REGULAR PLANNING COMMISSION MEETING

Wednesday, January 15, 2025 @ 7:00pm

Agenda Item: Application for Preliminary Plan Approval Major Subdivision #2400421

RE: Comments on Preliminary Plan dated October 15, 2024 (2nd Submittal)

TOWN OF FRONT ROYAL STANDARD CONSTRUCTION DETAILS	RC-5
	RESIDENTIAL DRIVEWAY CONSTRUCTION	DATE: MAY 2004 REVISION:

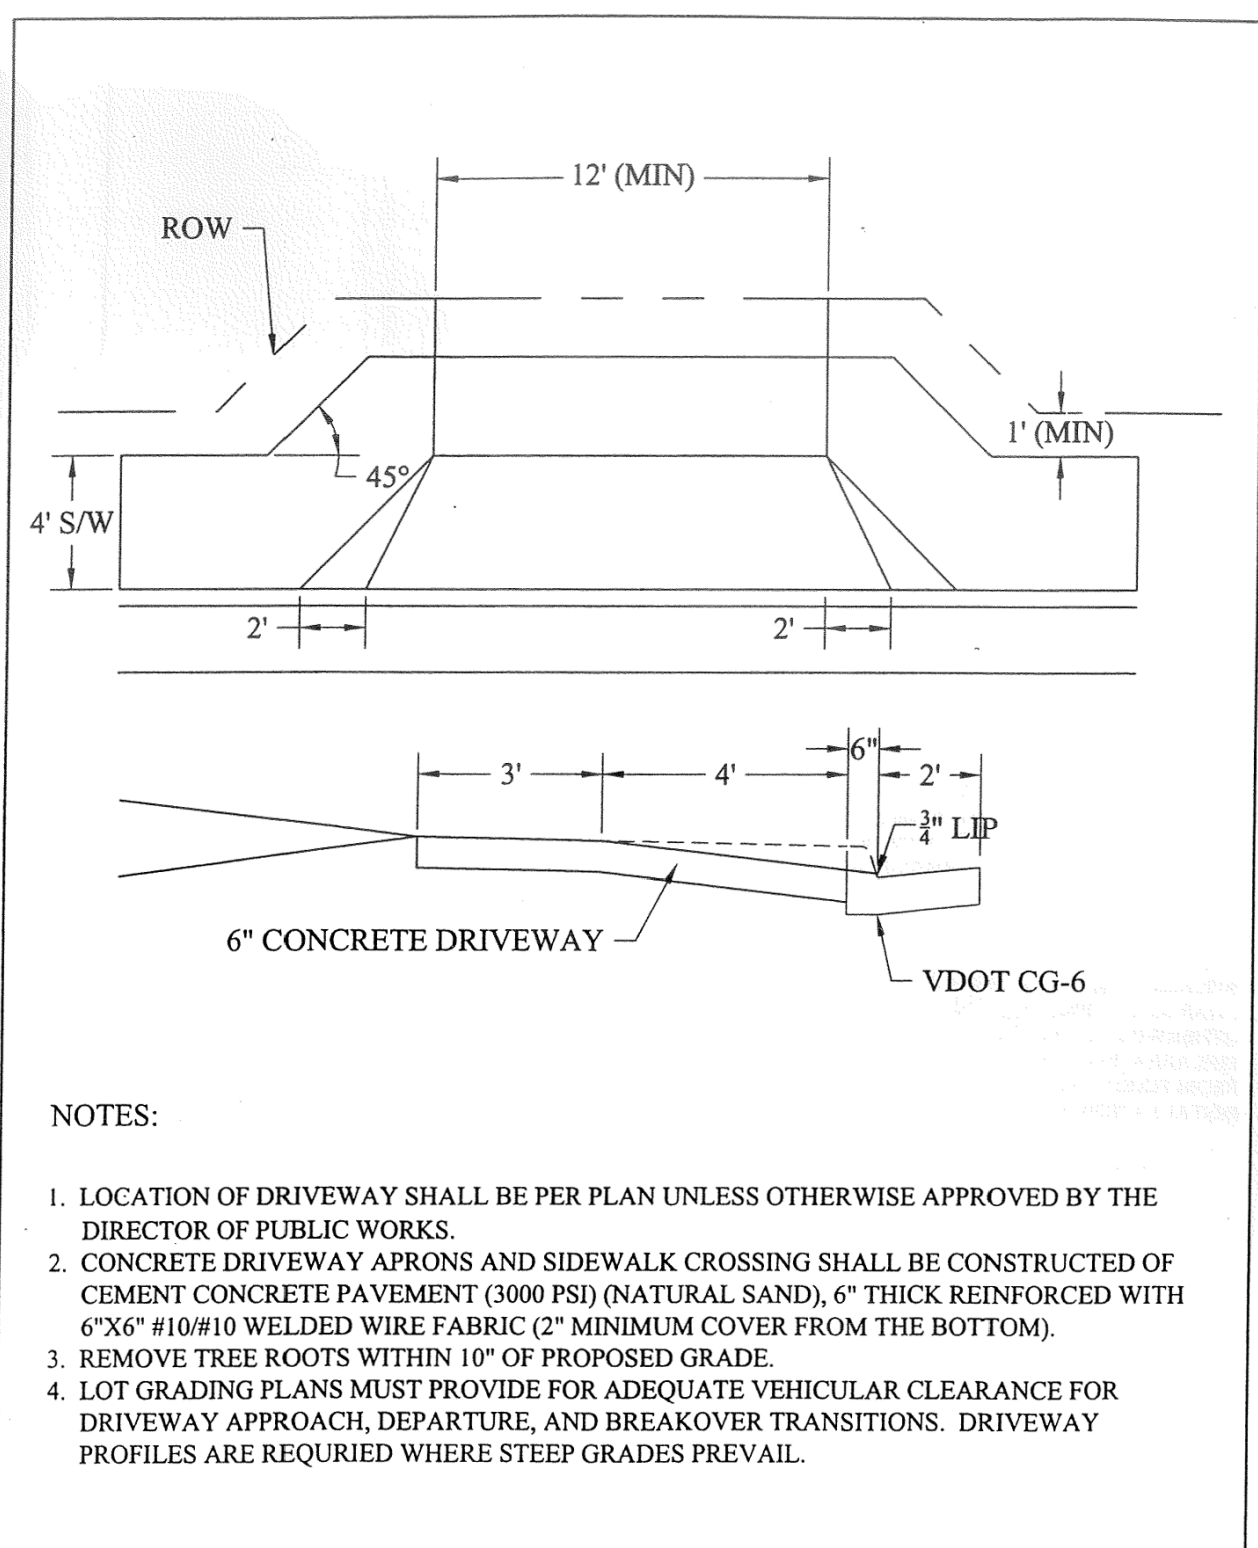
7. Sheet C200 needs to have the CG-6 curb and gutter and CG-9 driveway aprons labeled and shown.
8. Sidewalk still needs to be shown on the plans, there's no approved waiver for the sidewalk at this time.
9. Town standards need to be added to the detail sheet, W-6, S-10, S-1, RC-1, RC-2, RC-4, and RC-5.

Response: Standard details have been added to sheet C503.
